Sydney Catholic Schools, Marist North Shore

Engagement with Sydney Metro

**State Environmental Planning Policy (Infrastructure) 2007
State Significant Development Application – SSD-10473
270 Miller Street, North Sydney
Request for additional information**

270 Miller Street, North Sydney (SSD-10473)

Job Name : SCS Marist North Shore
 Sketch Title:
 Footing Plan

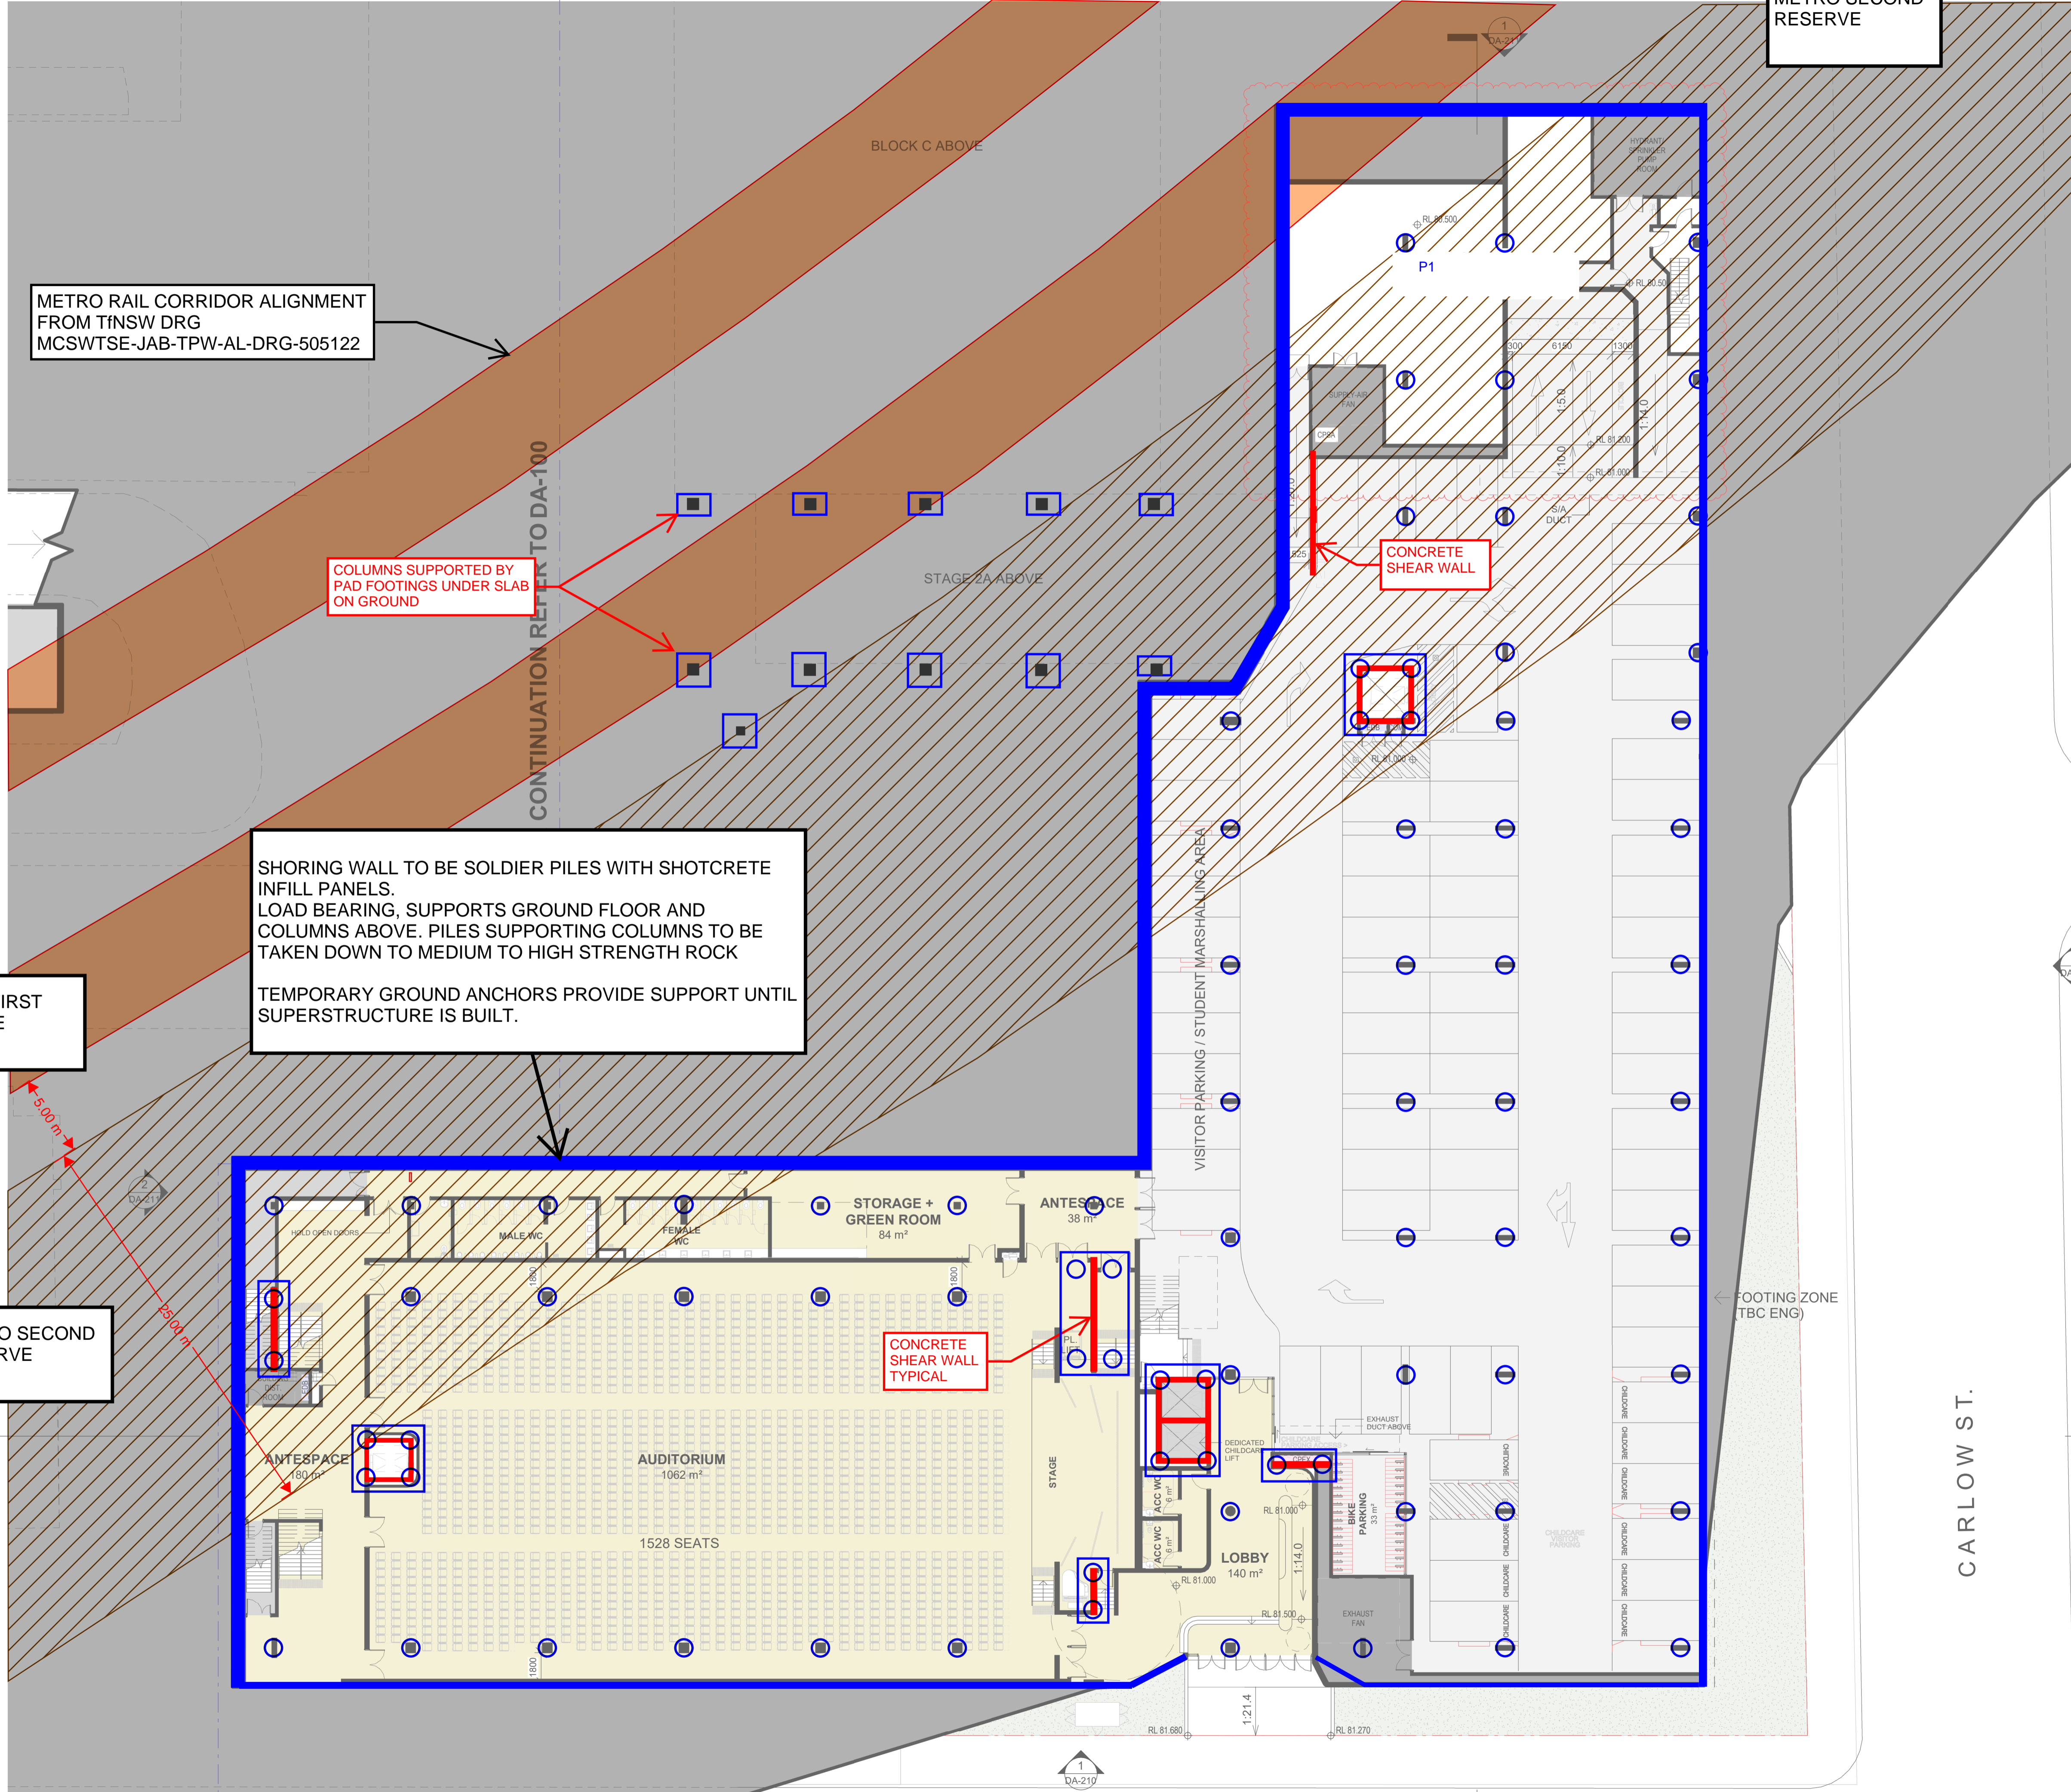
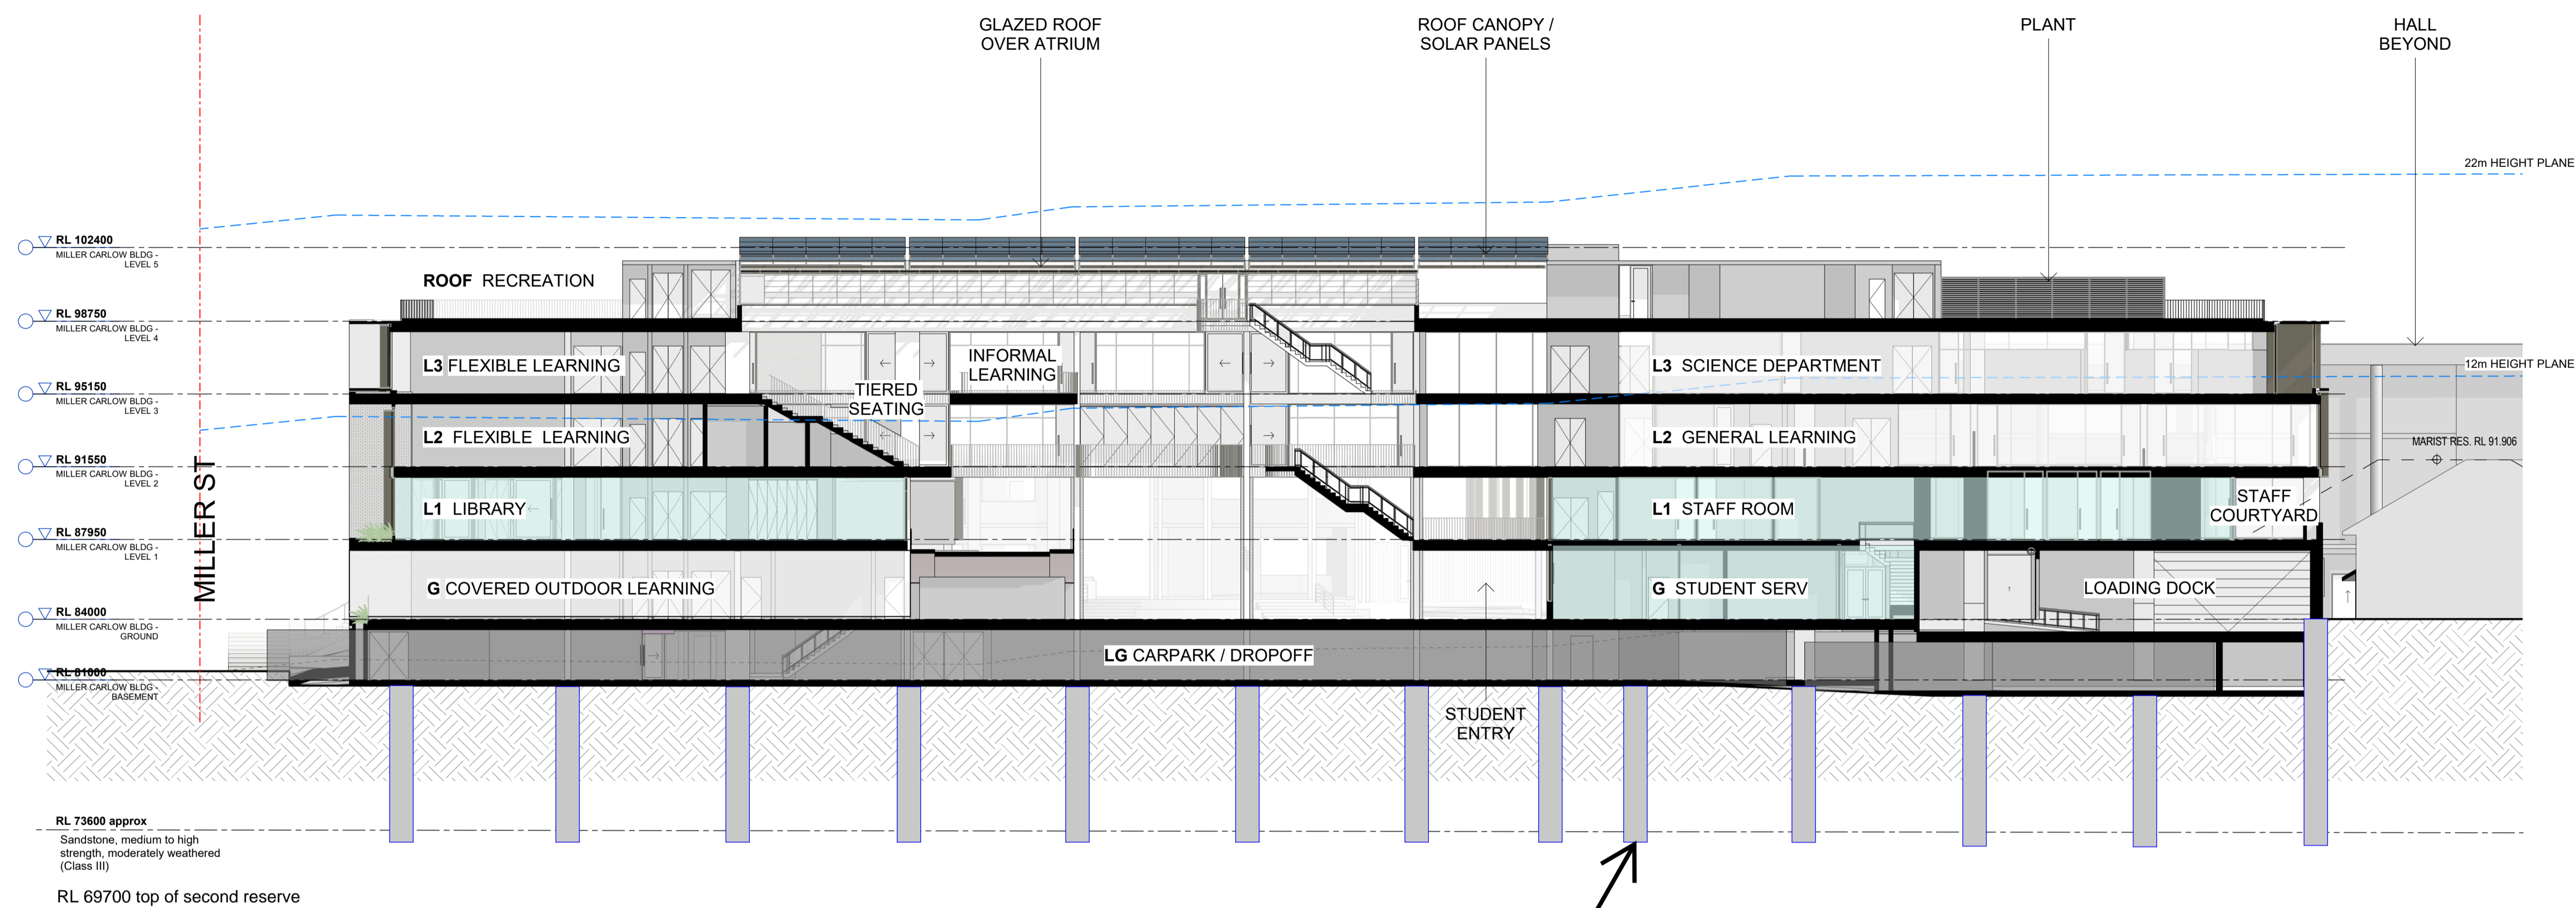
The plan drawing notes temporary anchors to be provided to support retention until superstructure built but the location/extent of these has not been shown. As such, the technical team has requested confirmation that all pile anchors will lie outside the second reserve.

Please also provide a Safety Work Method Statement (SWMS) with confirmations of pile anchors.

The footing plan (SK210803.MB01) and section (SK210803.MB02) have been updated to include temporary pile anchors which, similar to the pile footing strategy, will lie outside the Metro reserves. I have also attached our SWMS noting the pile anchors as a potential hazard.

Job Name : SCS Marist North Shore
 Sketch Title:
 Building Section
 Date: 14/06/2021
 By: ...
TTW Taylor Thomson Whitting Job Number: 181863
 Sketch No. : SK210614.02

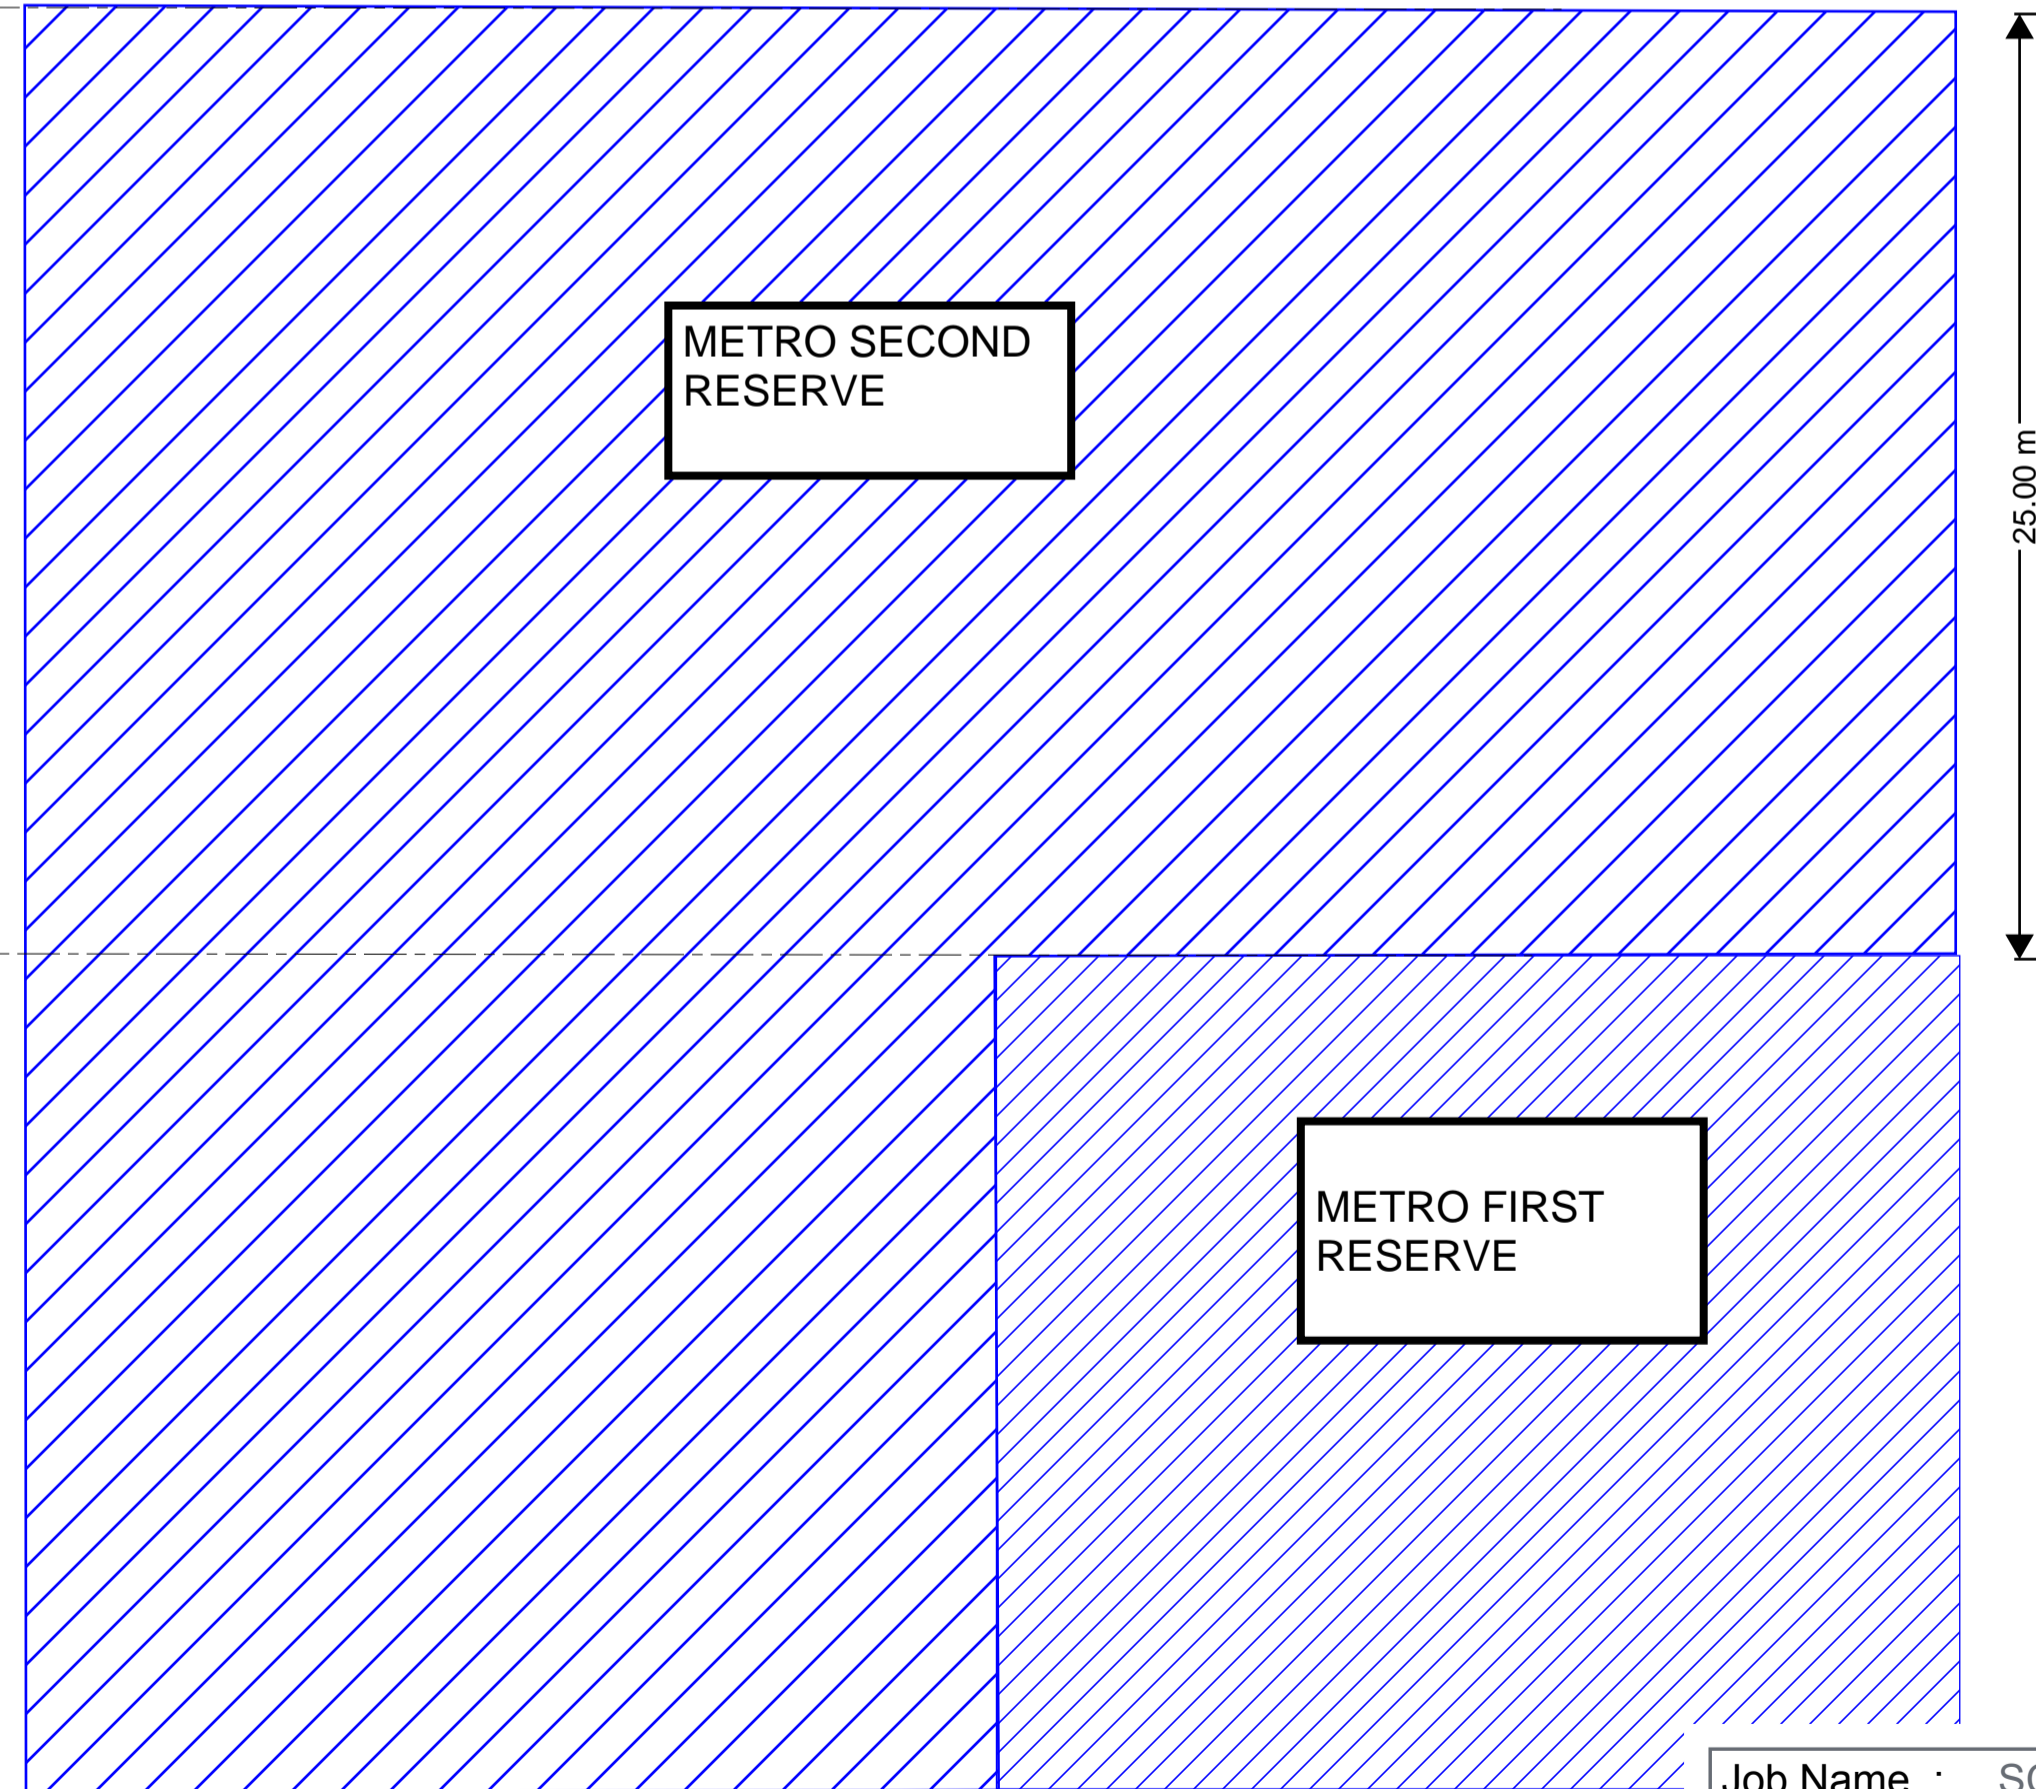
- It is requested that the final design of pile foundation should be provided in order to confirm the risk levels on Sydney Metro infrastructure.

We have also prepared a ground section SK210526.03 showing the relationship between Piled Footings and tunnel reserve, where our strategy is to bear the building footings on the rock and remain outside the second reserve. Our interpretation of Sydney Metro Underground Protection Guidelines – Section 5.1 is that the development lies outside the protection reserves, therefore we are not required to develop any supplemental information beyond the plans and sections provided.

PILES TO SOCKET INTO ROCK ABOVE SECOND RESERVE,
DO NOT EXTEND INTO SECOND RESERVE.
